re: **Grading and Site Servicing Plans Review**
Proposed Warehouse Building
6165 Thunder Road, Ottawa, Ontario

date: September 15, 2025

file: PG6430-MEMO.01

Figure 3 - Typical Frost Insulation Detail

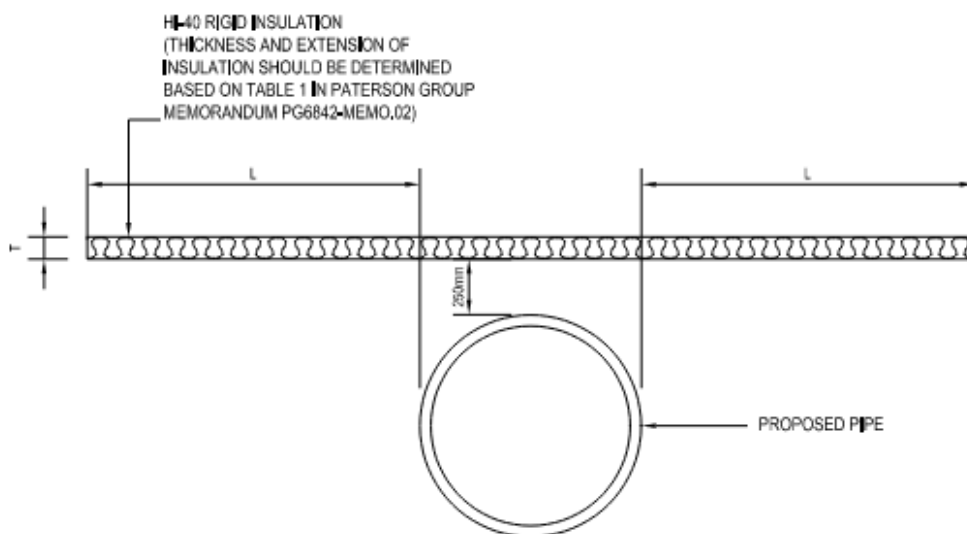
Further, it should be noted that all watermain pipes have been provided with sufficient soil cover at the subject site for the frost protection. However, insufficient frost protection has been provided for the majority of the proposed storm pipes throughout the subject site. The proposed storm pipes are located within the frost zone, which is the zone located within the upper 2.1 m below the finished grade. It is understood that the proposed storm pipes will be insulated. It is recommended that Paterson review the insulation detail to provide an input from a geotechnical perspective.

All rigid insulation should consist of either Dow Chemical High-Load 40 (HI-40), Styro Rail SR.P400, or equivalent approved by Paterson. The placement of all insulation within the service trenches must be reviewed and approved by Paterson personnel at the time of construction. Reference should be made to Figure 3 - Typical Frost Insulation Detail below:

The above detail can be used if the storm pipe is confirmed to be within the frost zone. Insulating the pipe alone without the soil may cause differential settlement in the future, therefore, the above detail provides a sufficient insulation to the pipe and the subgrade below the pipe.

FIGURE 1

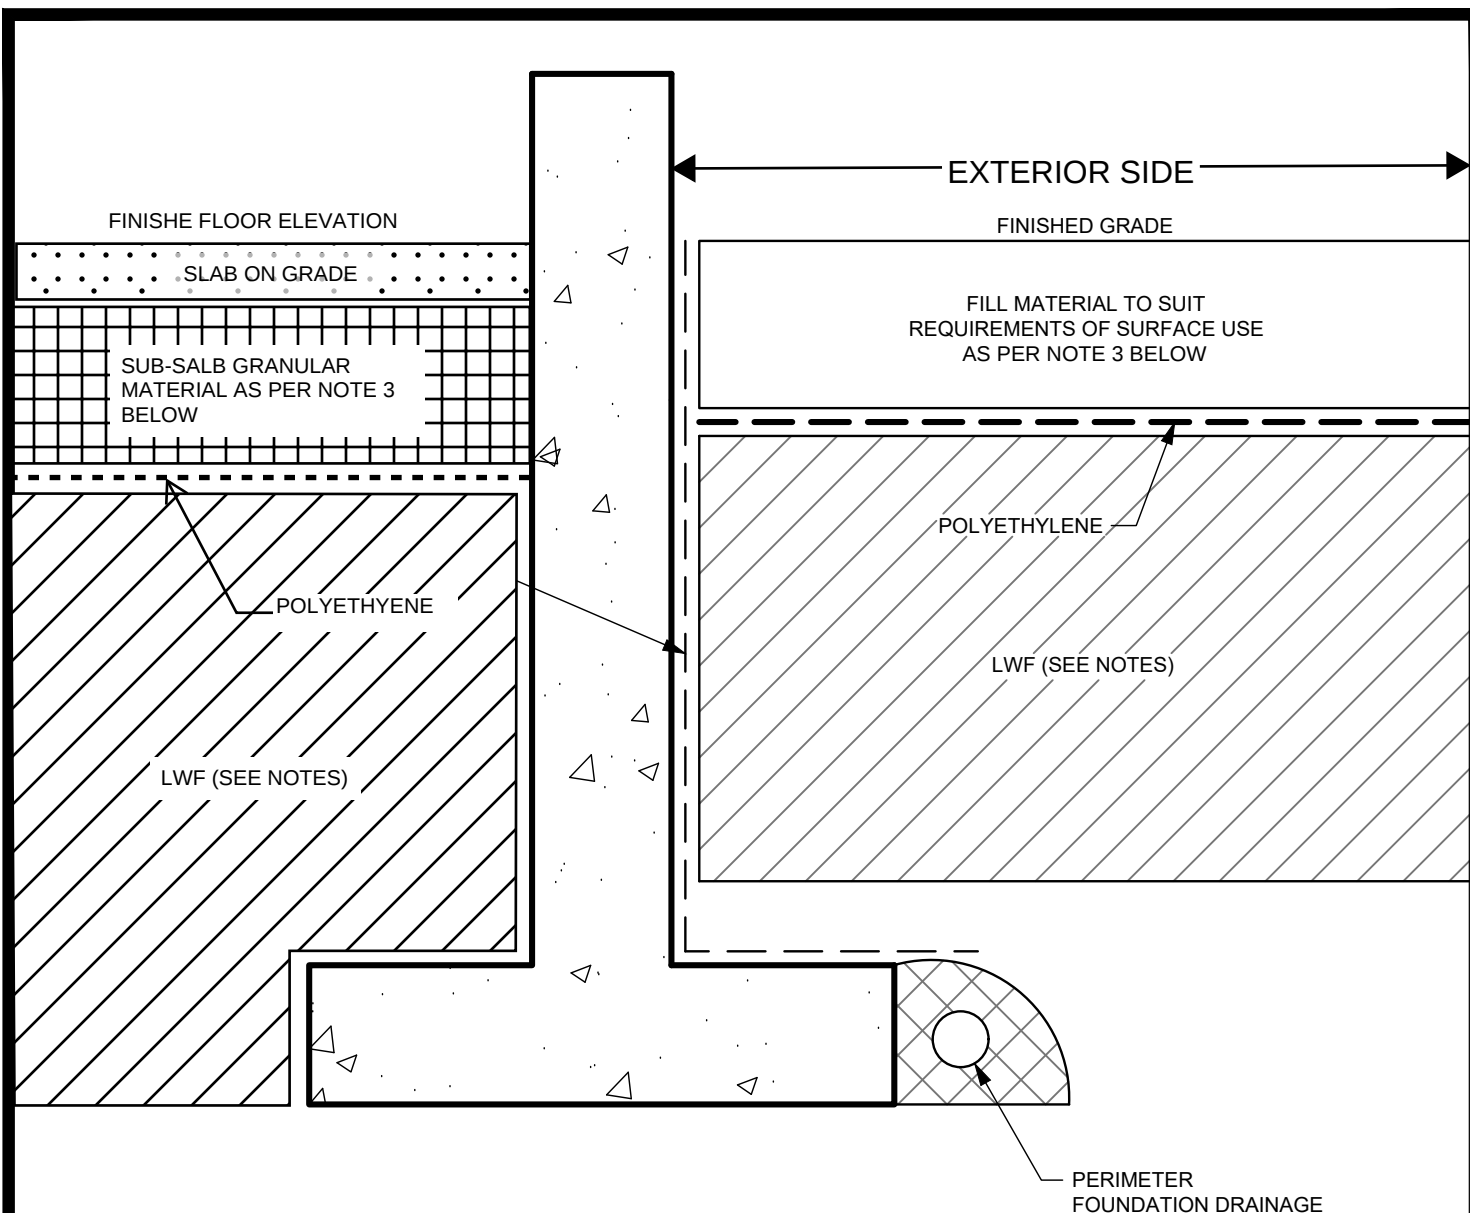
Based on our review of the above-noted drawing, the proposed building grading was found to be exceeding the permissible grade restriction assigned for the subject site within the footprint of the proposed building. The exceedances were found to range from 0.35 to 0.65 m above the permissible grade raise restriction. Therefore, LWF recommendations have been assigned to reduce the impacts of the load exerted from the additional soil needed to raise the grade to the proposed grades. It is important to note that the LWF will be recommended to be placed below the slab on grade as well as the perimeter of the proposed building extending horizontally a minimum 6 m beyond the foundation walls. Reference should be made to the attached Figure 1 – EPS Block Installation and Figure 2 - Lightweight fill Recommendations, attached to the end of this report.
